STAFF REPORT: 3/16/2022 REGULAR MEETING

ADDRESS: 86-92 E. FOREST

APPLICATION NO: #22-7716

SCOPE: DEMOLISH AND REBUILD EAST/SIDE ELEVATION ADDITION; REPLACE SLATE ROOF; REHABILITATE BUILDING; AND ESTABLISH NEW PARKING LOT

92 E. Forest, current conditions

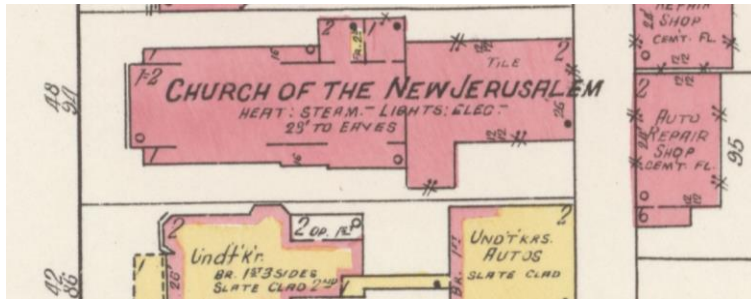
- It is staff's opinion that the brick chimney at the building's rooftop which is proposed for removal is character-defining and therefore should not be removed. It is highly visible when viewed from the right-of-way and does not to be in poor condition

- Staff has not yet received documentation which clearly demonstrates that the current slate roof is deteriorated to an extent that merits its wholesale replacement. Staff therefore does not recommend its replacement at this time

- The existing brick chimney shall be retained/shall not be removed
- Details for the new gutters and downspouts shall be submitted to HDC staff for review and approval prior to the issuance of the project's permit. If staff determines that these elements do not meet the SOI standards, the work items shall be submitted to the Commission for review at a regular meeting
